CITY OF CARMEL-BY-THE-SEA PLANNING COMMISSION

REGULAR MEETING Wednesday, September 13, 2023

TO:	Chair LePage and Planning Commissioners
SUBMITTED BY:	Evan Kort, Associate Planner
APPROVED BY:	Brandon Swanson, Community Planning & Building Director
SUBJECT:	DS 23-022 (Bellasis): Consideration of a Final Design Study, DS 23-022 (Bellasis), and associated Coastal Development Permit for a 716-square foot addition to an existing one-story single-family residence, including a new 509-square-foot second story located at 4th Avenue 2 northeast of Lobos Street in the Family Residential (R-1) Zoning District. APN: 010-013-004-000.

A2.2

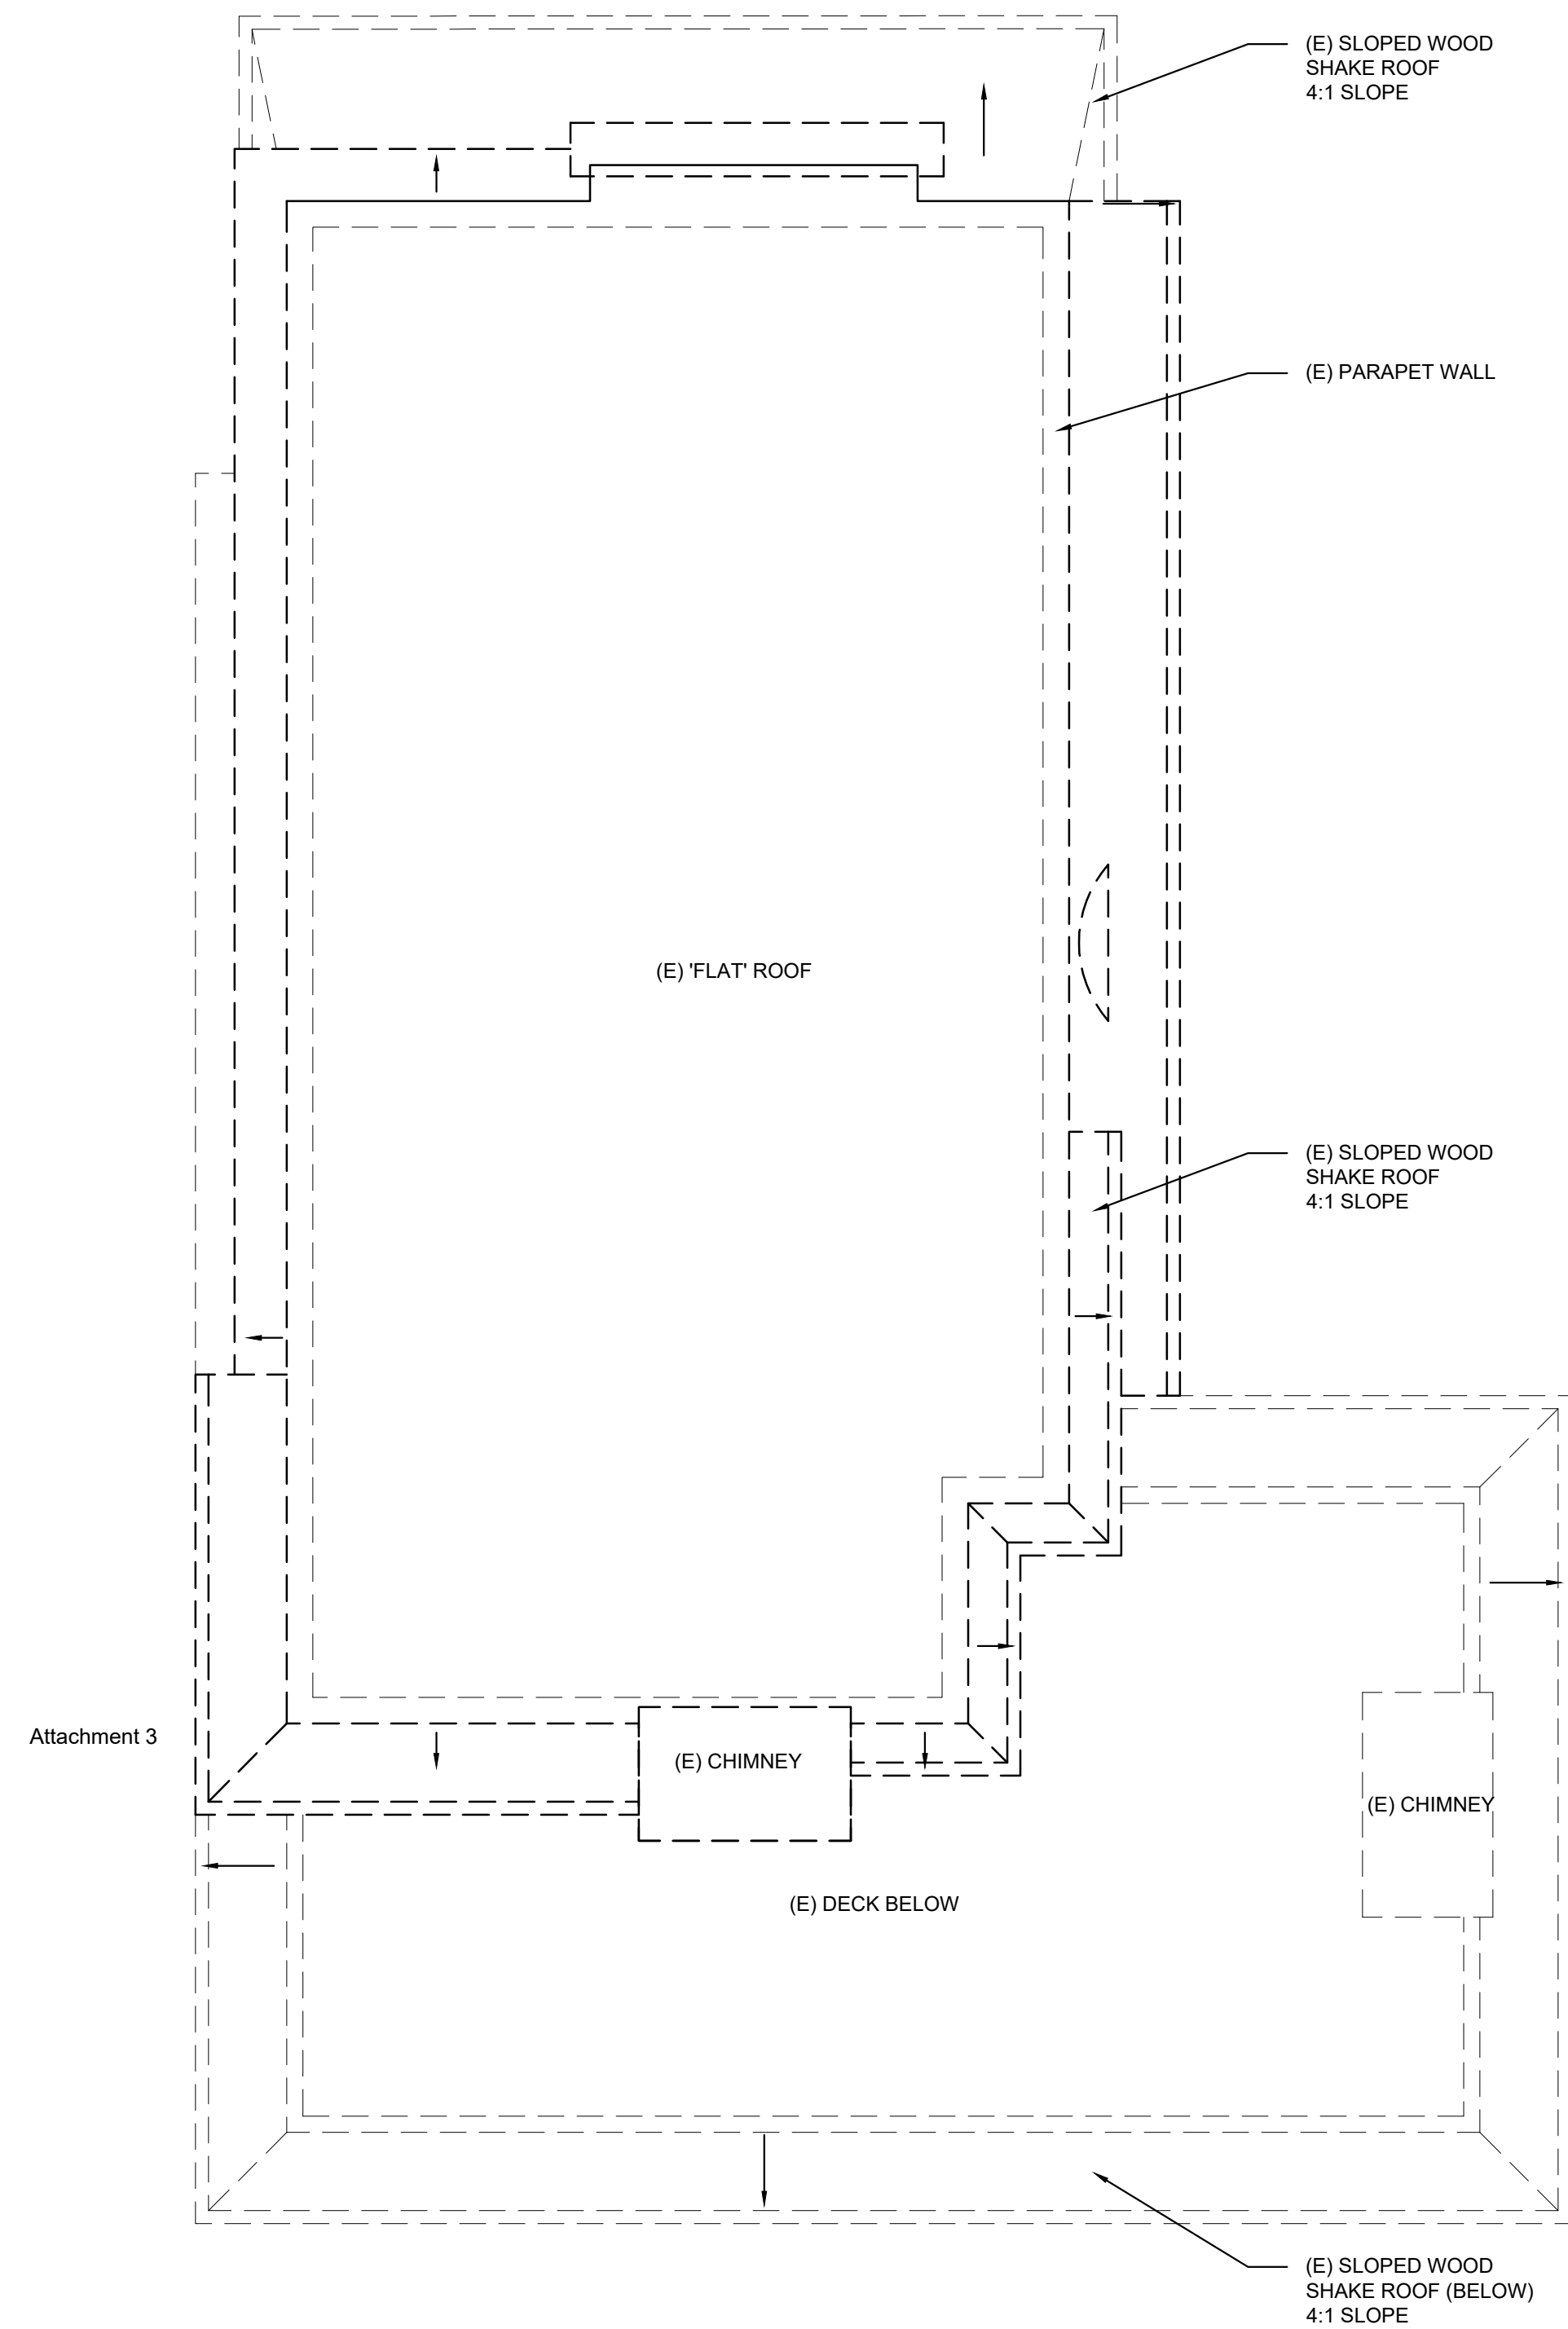
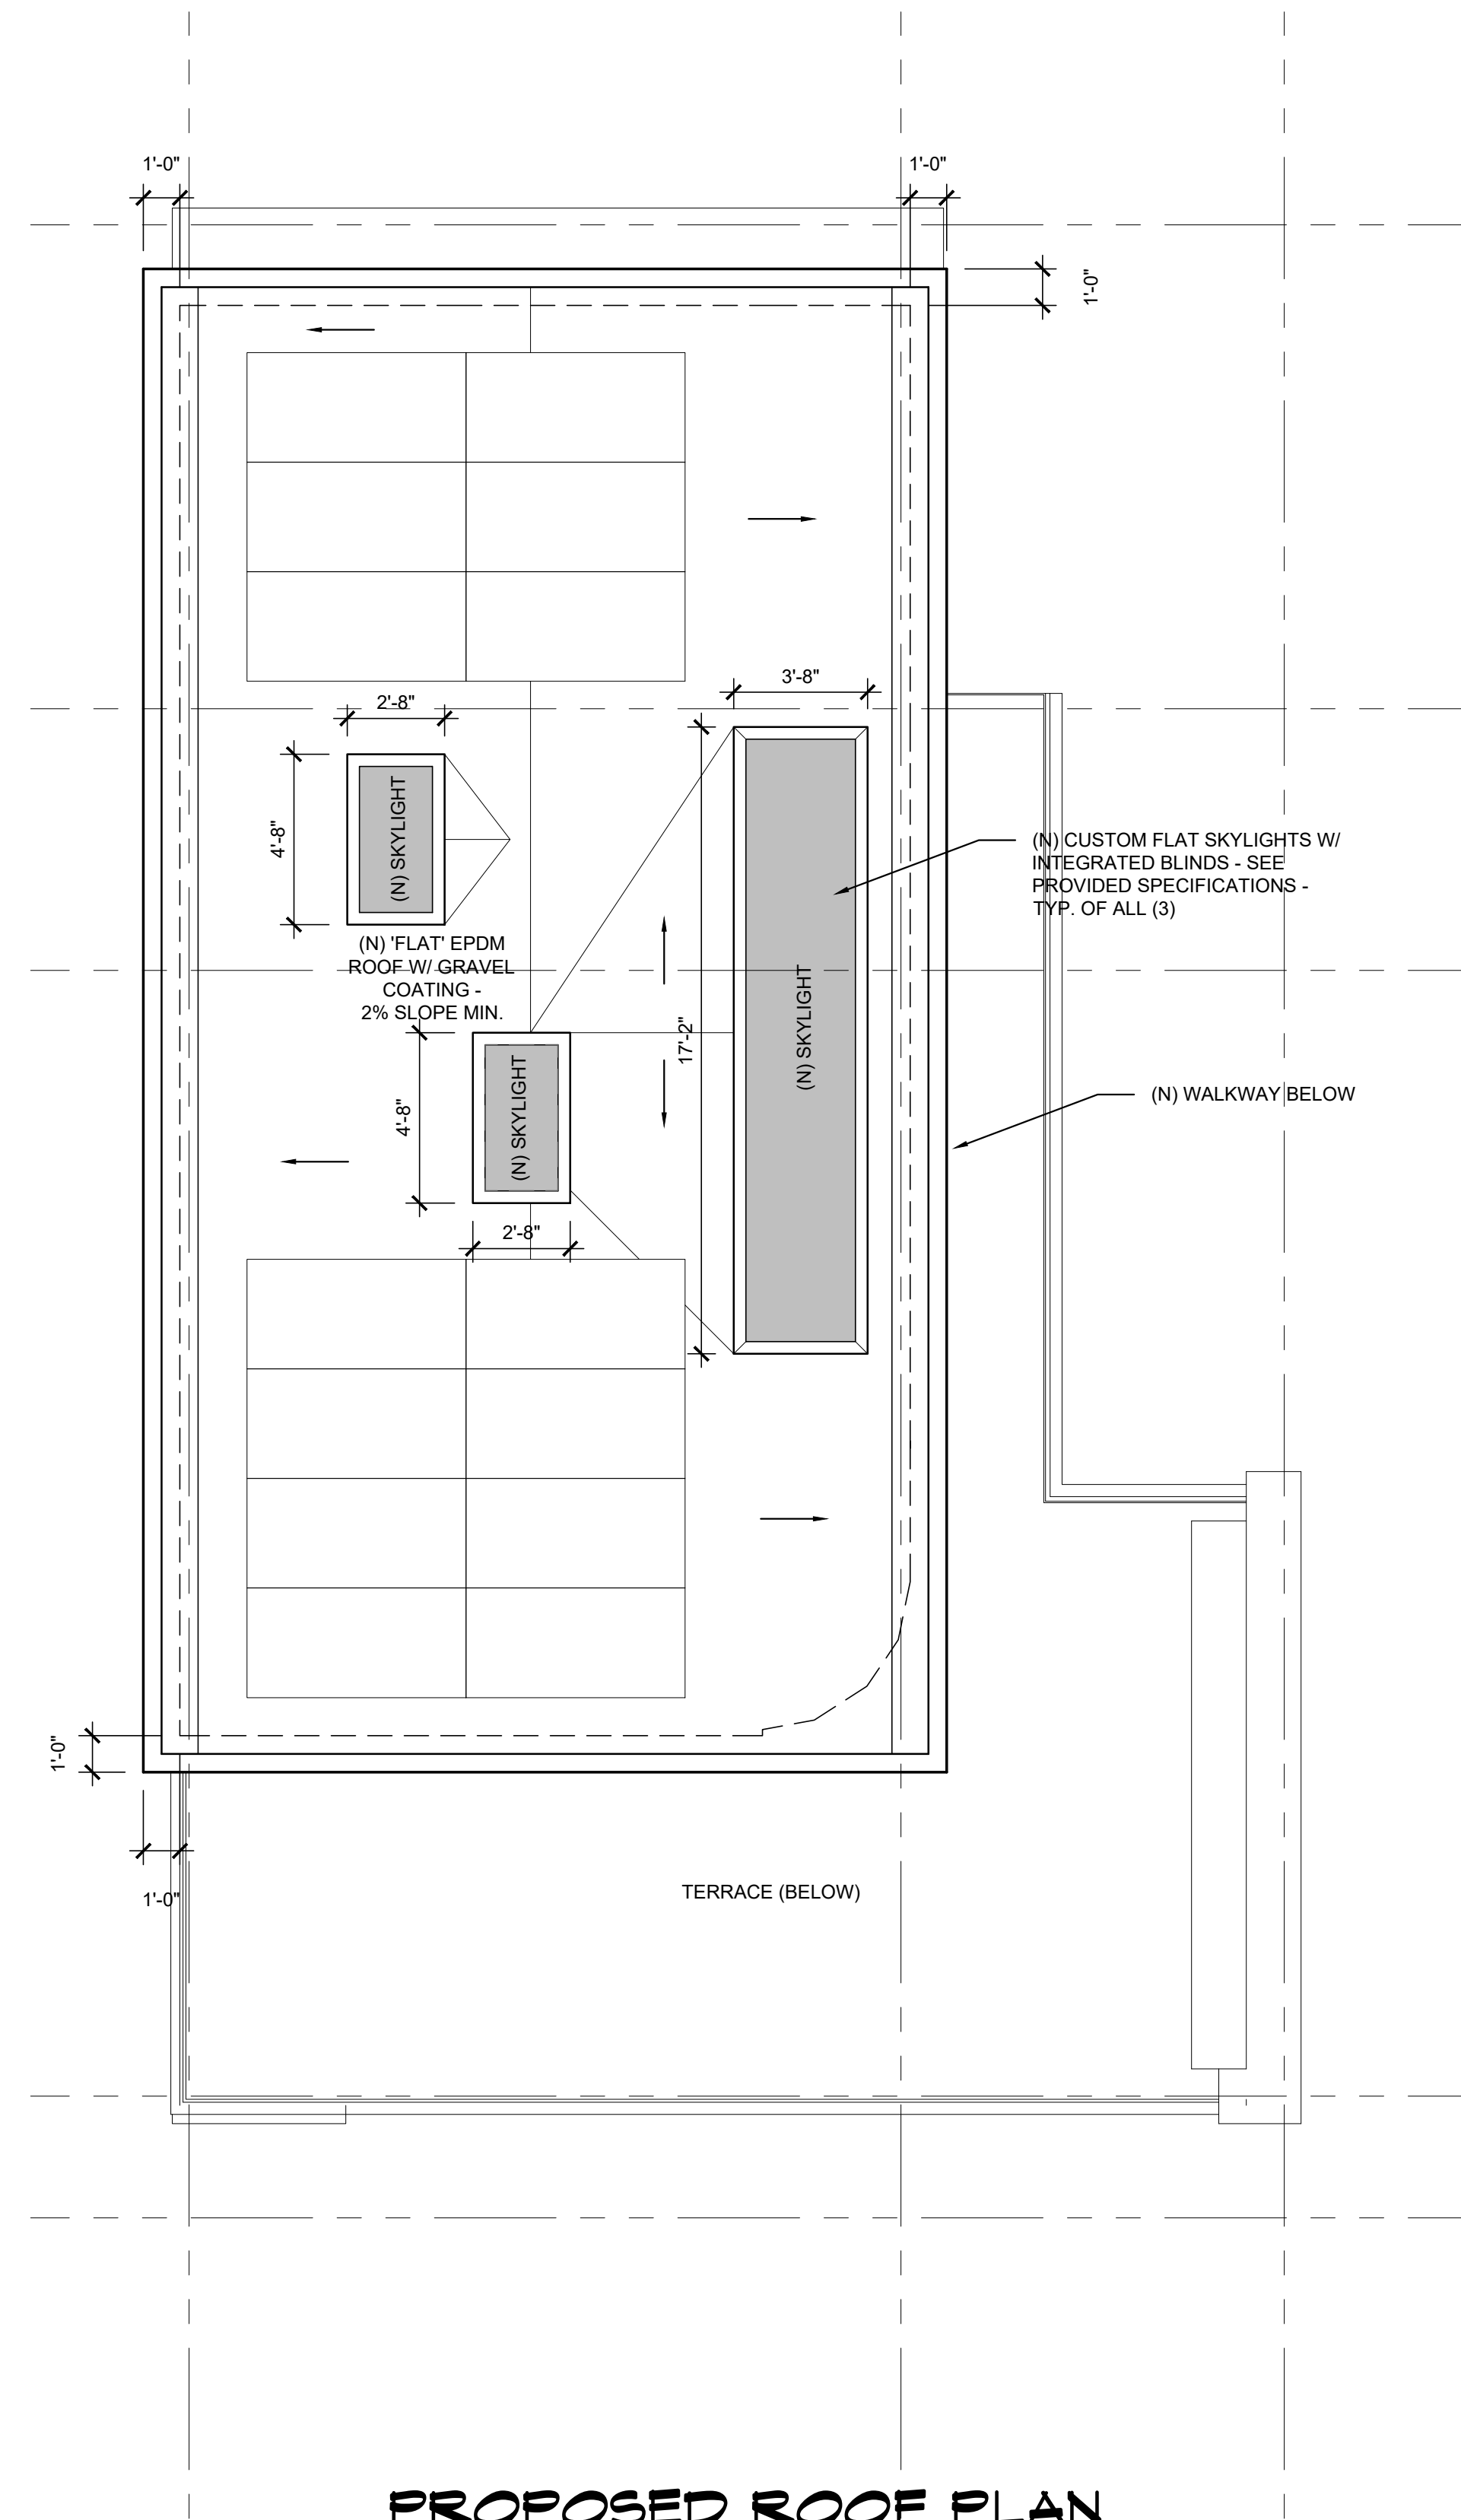
The applicant has provided a comprehensive demolition plan (refer to Attachment xx, Sheets A2.0 and A2.2) illustrating the extend of the demolition work, thus maintaining the non-conforming floor area.

Special Condition of Approval #41 has been included stating, "All exterior demolition shall be in substantial compliance with the approved demolition plan as shown on Sheet A2.0 and A2.2 of the Design Study Plans Approved by the Planning Commission on September 12, 2023. Changes to the demolition plan shall be approved in writing by the Community Planning and Building Department prior to commencement of any additional demolition work. If during construction the exterior demolition exceeds what has been approved, a cease work order may be issued any time at the discretion of the Director of Community Planning and Building and with revised plans submitted to the Department of Community Planning and Building that correct the non-nonconformities in respect to the buildings floor area."
